Presentation to the Commission

Combined License Application Review

Vogtle Units 3 and 4

SER Panel 1
September 27 – 28, 2011

AP1000 Shield Building Design

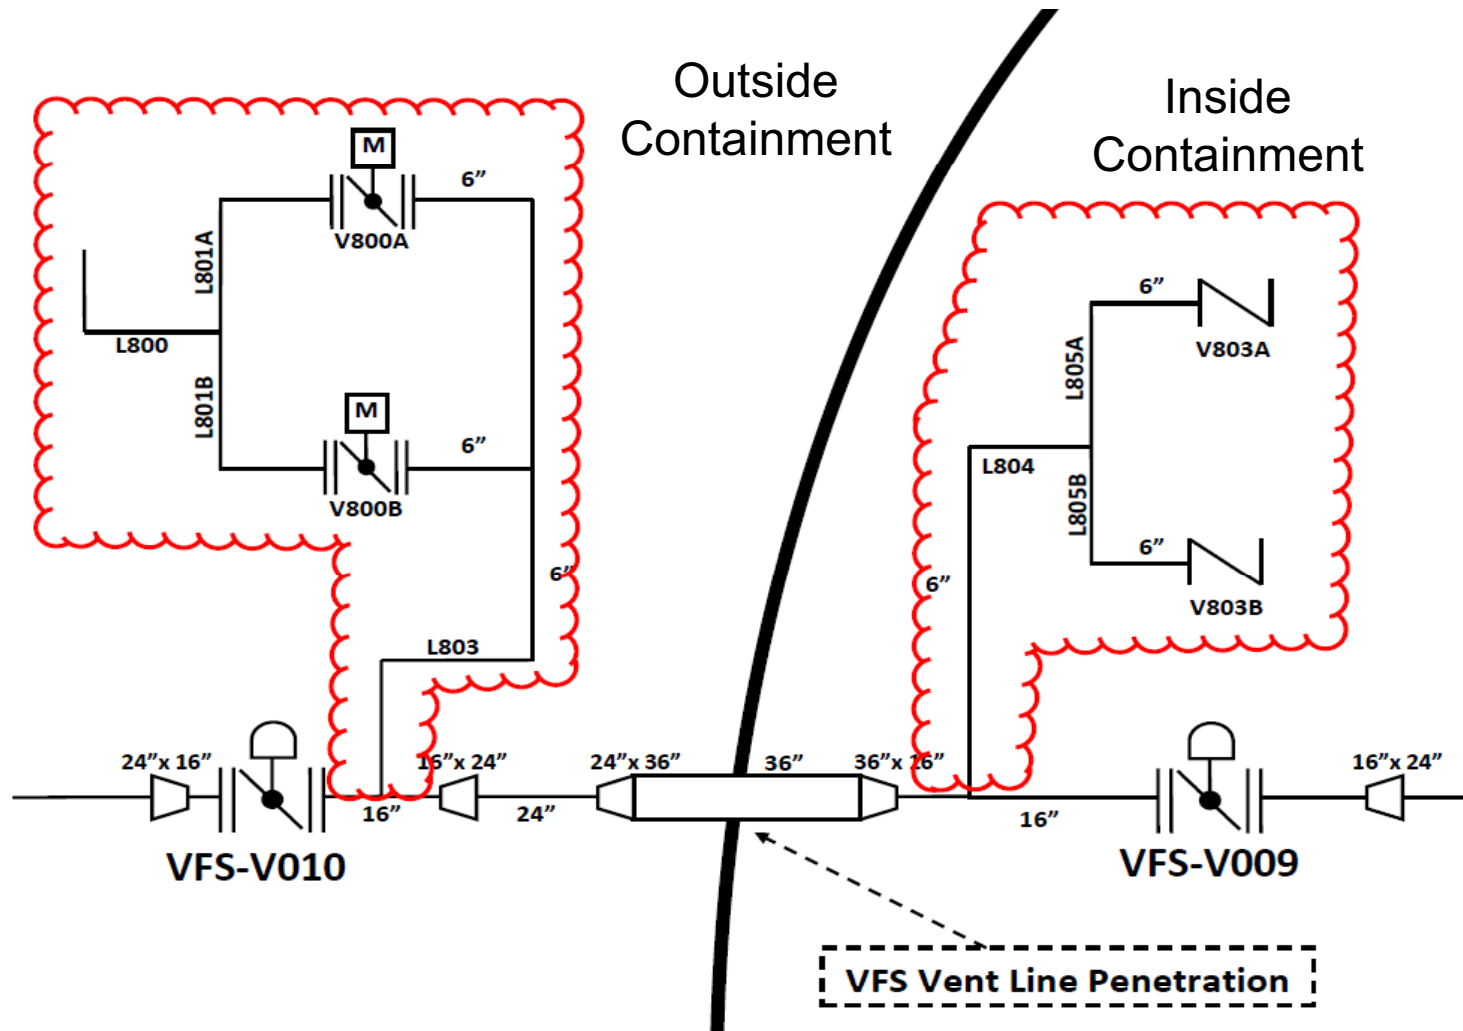
- Revised design for improved aircraft impact resistance
- First of a kind use of modular construction
- Review for external events (e.g., seismic)
- Inspection of supporting information on aircraft impact performance
- Revision 19 additional topics
